Access Compliance Report

Public Rights-of-Way

| Intersection ID: 44910 | Main Street: FOX_POINT_DR | Cross Street: OAKBURN_DR | Location: SE |
| ADA ID: 620DD3492E33 | Ramp Type: Perp | Initial Pass/Fail: Fail | Overall Compliance: No |

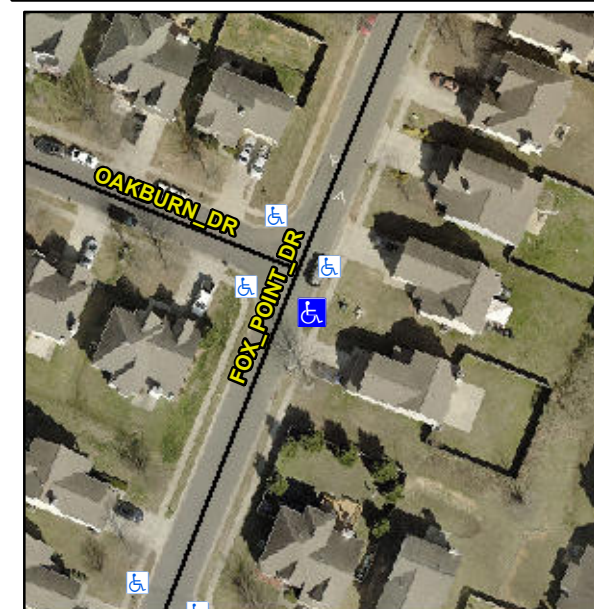
Not Found, R304.5.1, R304.2.2

| Compliance | Description | Data | Compliance | Description | Data |
|------------|-----------------------|-------|------------|-----------------------------|------|
| N/A | Ramp Length (in) | 47.5 | No | Ramp Slope (%) | 10.5 |
| No | Ramp Width (in) | 46.5 | Yes | Ramp XSlope (%) | 1.1 |

Remove & Replace Entire Ramp.
